Maule Aircraft Corporation

SERVICE LETTER #17

MODELS AFFECTED: M-4C, M-4-210C & M-4-220C

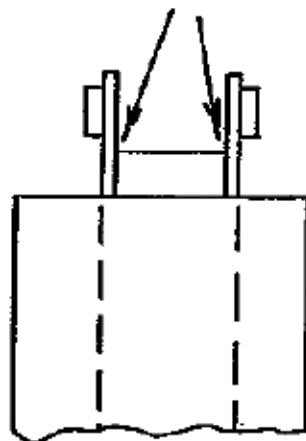
We have found a slight crack or die mark in the Flap and Aileron Hinge Brackets at the points as illustrated below. A through inspection should be made to assure that there are no cracks on your Brackets.

If cracks are found, they can be repaired in the following manner:

- (a) a crack $1/16$ inch or less may be filed out with a round 4 to 6 inch file, or
- (b) cracks $1/16$ inch or over should be half-arc or mig welded.

This inspection should be accomplished before your next flight and if cracks are found, the repairs should be made before flying. Enclosed you will find a card, please fill out and return.
